ADDENDUM NO. 6

DATE: March 20, 2020

PROJECT: Hammond High School Renovation and Addition
Columbia, Maryland
Architect Project No. 18011

FISHER, COLLINS, CARTER 10272 BALTIMORE NATIONAL PIKE ELLICOTT CITY, MD 21042 410-461-2855(P)	HAMMOND HIGH SCHOOL RENOVATION AND ADDITION	SCALE: NO SCALE ADDENDUM 06 DATE: 3/20/20
	ITEM: REMOVE STORM DRAIN PROFILE TO M-15	AD-C16

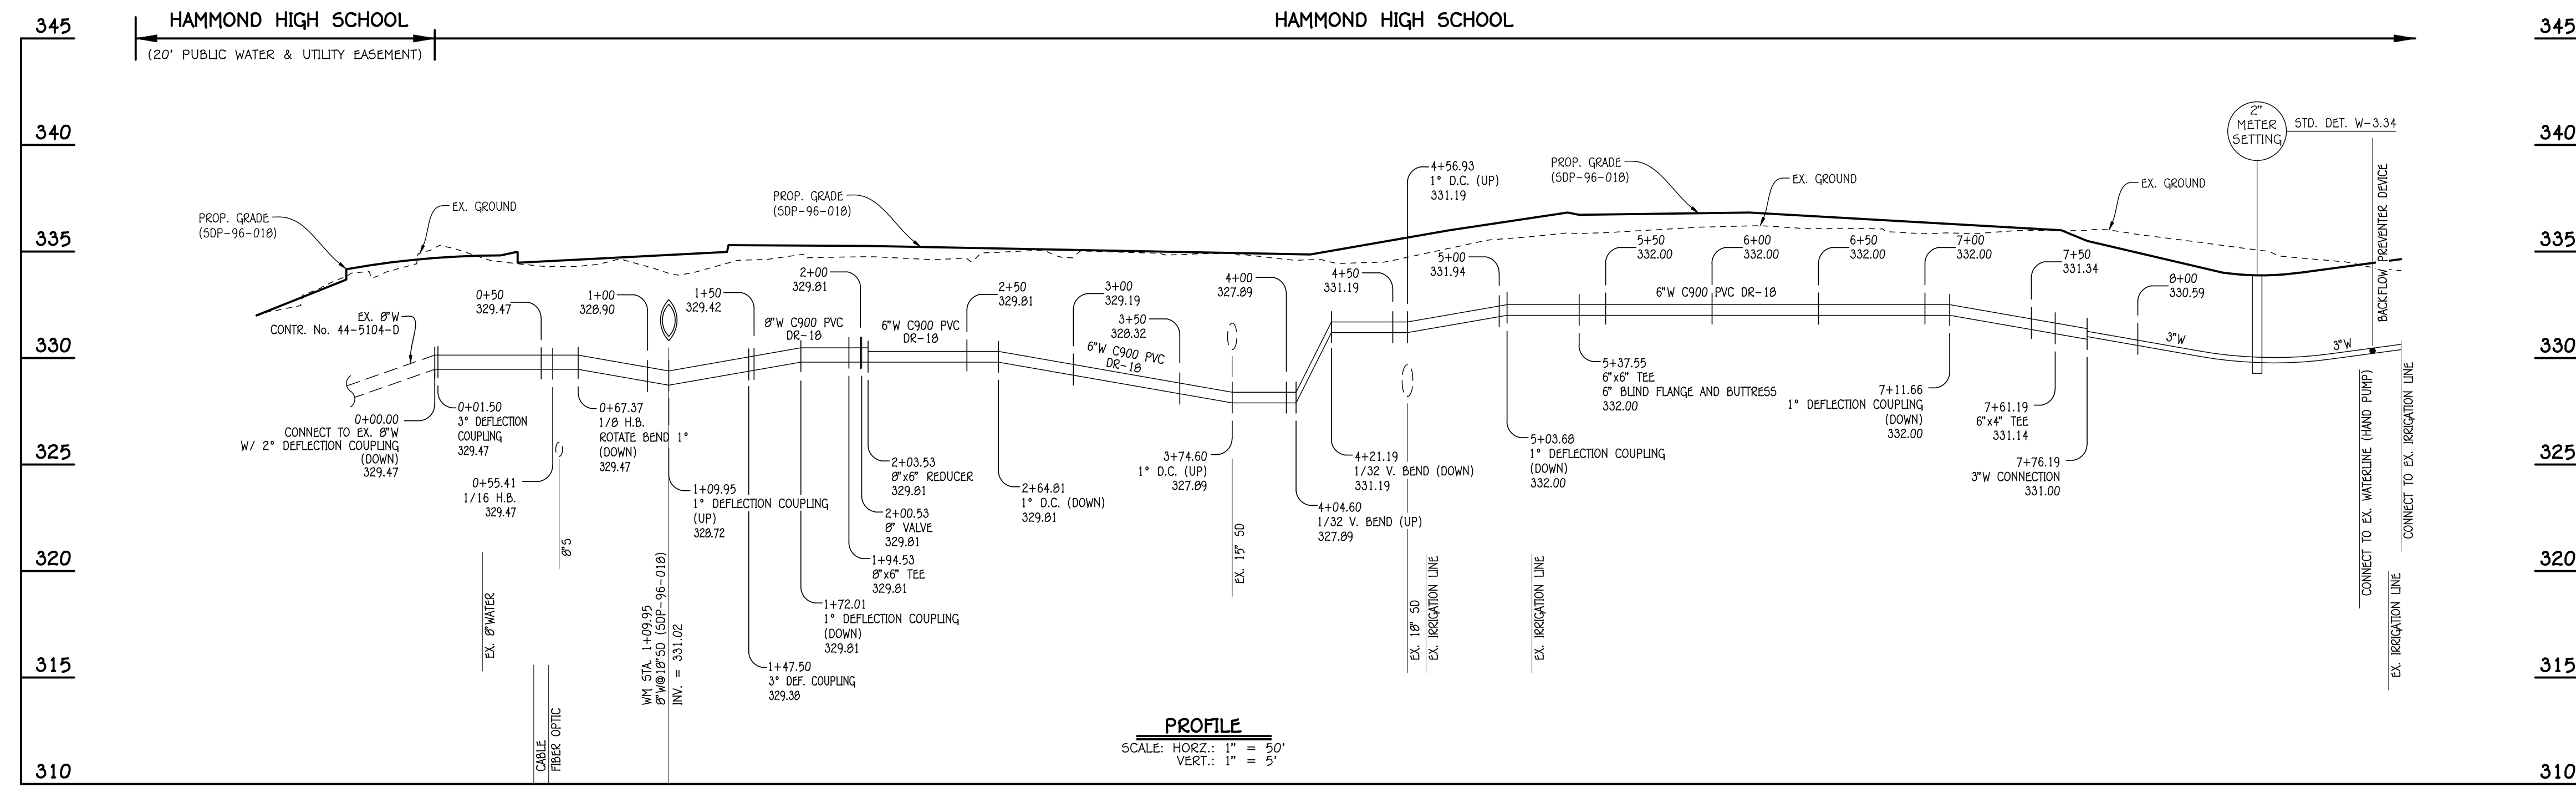
- C1 – TITLE SHEET AND SEQUENCE OF CONSTRUCTION
 - REVISE** sheet index as shown in sketch AD-C14
- C13 – PROFILE AND DETAIL SHEET
 - ADD** Schedules as shown in sketch AD-C15
- C29 – SWM PROFILES, PLANTING PLAN AND STRUCTURE SCHEDULE
 - ADD** Schedules as shown in sketch AD-C16
- C33 – WATER PROFILE AND CHART
 - ADD** sheet in its entirety, attached
